The following guidance and clarifications are provided as part of REACs continuing effort to minimize the variances in the application of the UPCS protocols and definitions.

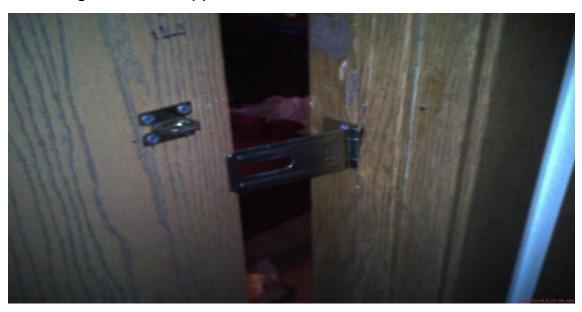
- Are thumb latches suitable substitutes for window locks? Yes. As long as they
  can be operated without the use of a tool.
- Are sash pins (with or without a chain) suitable substitutes for defective balances? Yes. But they must be tested to ensure they function.
- Some inspectors allow the escort to operate the windows, especially if they are
  difficult or the inspector fears damaging the window. Is this allowed? The
  inspector shall operate all windows except those that are not accessible due to a
  large bed blocking access or the window is elevated. In each of these cases the

inspector must observe the window being tested, either by the escort or the resident.
